Sent: 29/06/2022 9:28:43 AM
Subject: FAO: Alex Keller - Objection letter re: DA2022/0646 at 122-124 Queenscliff Road, Queenscliff
Attachments: Objection letter 122-124 Queenscliff Road Queenscliff- DA20220646.pdf;

**Submission raising objection to Development Application DA2022/0646
Demolition works and construction of a residential flat building at 122-124 Queenscliff
Road, Queenscliff**

Figure 6 – Proposed roof terrace and spa area only approx. 4 metres from client's bedroom windows and first floor balconies

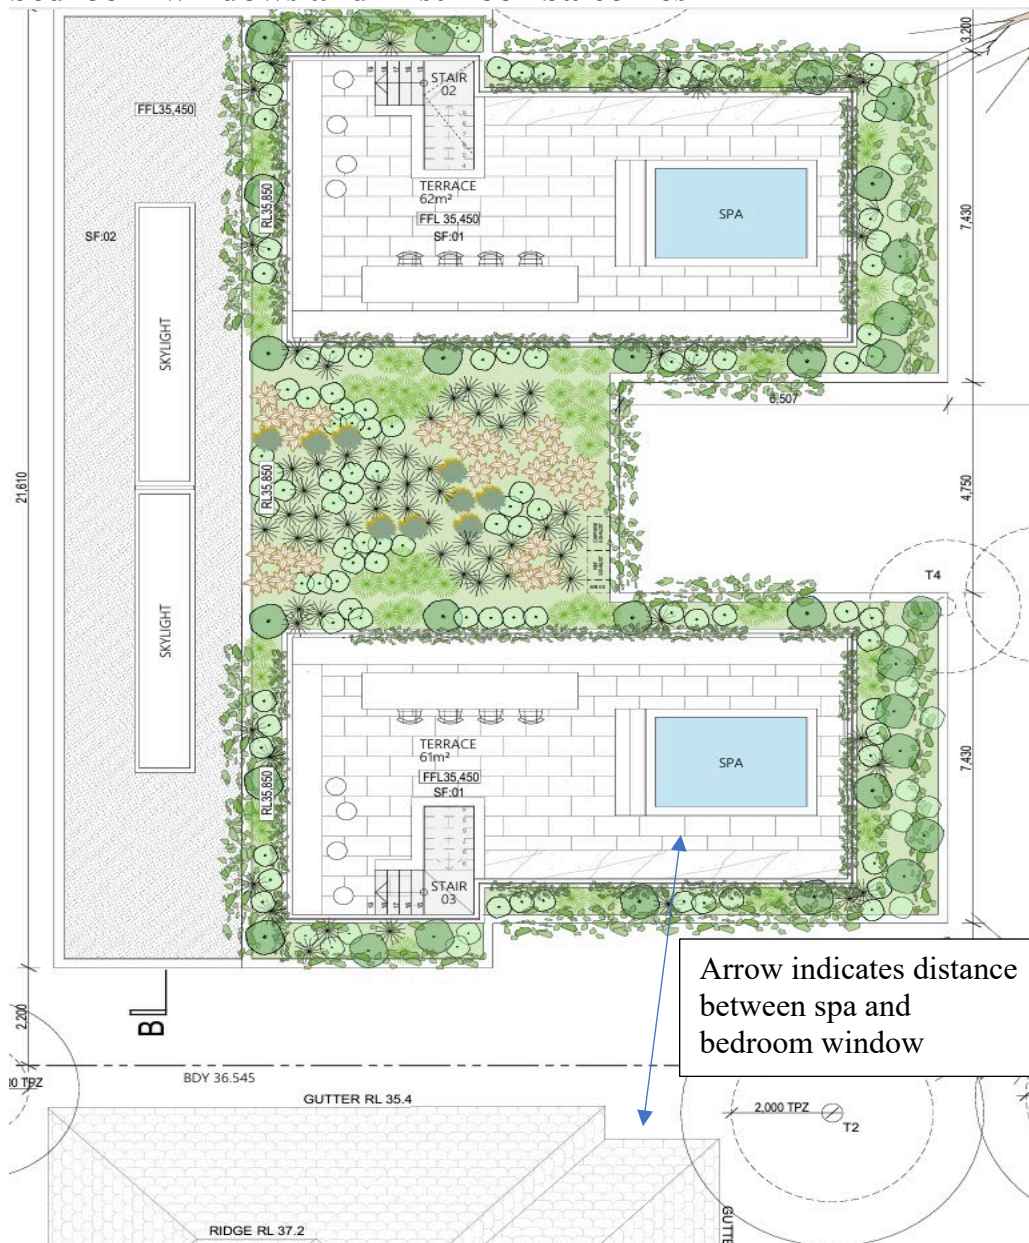
Roof top terrace and spa area

Comment: The proposed roof terrace and spa area will directly overlook my client's bedroom windows and on to the rear balcony area. The degree of harm to visual privacy will be significantly detrimental. Acoustic impacts will create further harm, particularly by virtue of the proximity of the spa from my client's bedroom windows.

- Pull back the side setbacks at the eastern elevation of the proposed development as the wall height increases and pull back the south eastern corner to assist with view sharing.
- Remove the roof terrace and spa area proposed over the third storey (over Level 01).
- Remove Level 01 or reduce the height to reduce the identified impacts.
- Should Council approve the proposed development without requiring that Level 01 be removed, the internal layout of apartment 1.02 at Level 01 needs to be amended to remove the bedroom window.

- Condition that the roof area be non-trafficable in perpetuity.
- No windows on the eastern elevation.
- No privacy screens or planters on the eastern elevation of the rear terraces.
- No plant, mechanical equipment or air conditioning units on the roof area or on the eastern side elevation.
